# Equipment safety & safety aspects in the LHC tunnel

***Engineering Design Review of DFM 18.01.2022***

# Recommendations from the DFM CDR

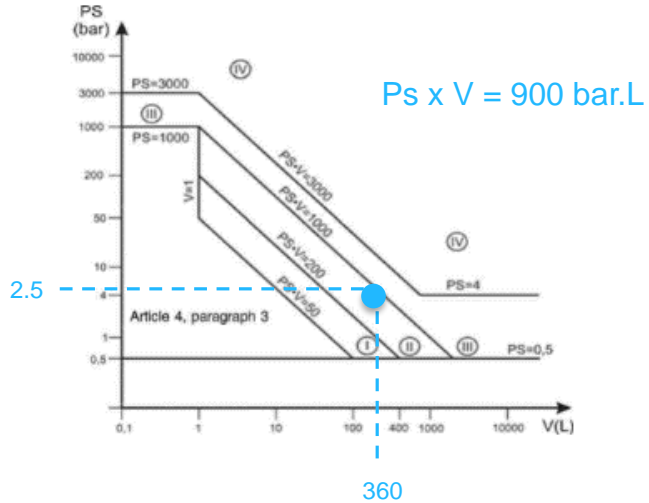
- [...] the radioprotection aspects make any intervention (apart from the first installation) critical for ALARA considerations.
- The plan for maintenance and reparation must be developed taking into account this aspects.
- More detailed sequence for all these operations are expected at the DDR review.
  - Detailed sequence for maintenance & repair will follow F2 test bench to include empirical knowledge (c.f. P.Cruikshank's talk #1)

- The DFM design and its technical documentation has to coherently address the point of the design standard applied (PED) and consequent requirements all along the procurement, assembly and testing phases.
  - ✓ Design standard will be presented and justified. Requirements will be addressed.
- The exact role of HSE should be identified and clarified.
  - ✓ HSE guidance used for the conformity compliance strategy. HSE's role is clear.
- The integration of burst disk, rated valve and relief plates must be done together WP15 and HSE.
  - ✓ Final integration of pressure safety devices made considering best safety practices.

# Cryogenic safety

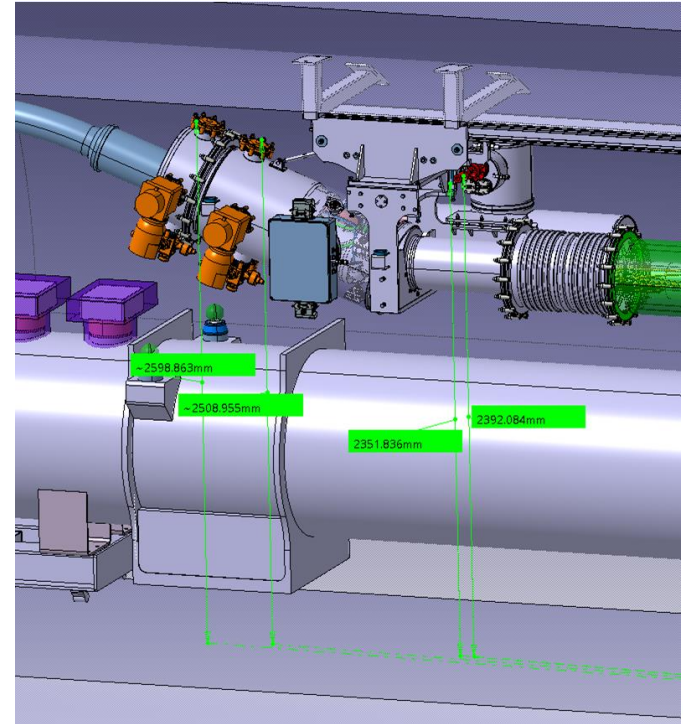
- Position of safety devices approved by HSE
  - Height of pressure relief devices wrt tunnel's floor between 2300 mm and 2600 mm: no risk of direct projection of cold helium gas on transport side.

- Relief device sizing according to ISO21013-3
    - Qm = 0.5 kg/s (1.4 kg/s for 10 layers)
    - Drelief > 17 mm (28 mm for 10 layers)
- ✓ Sizing of DFM burst disk covers the dimensioning scenario with margin.

- ✓ Relief plates sizing checked at CDR: 2 DN100 on either side of the VB.
- Staggering protection concept (c.f talk of V.Gahier)
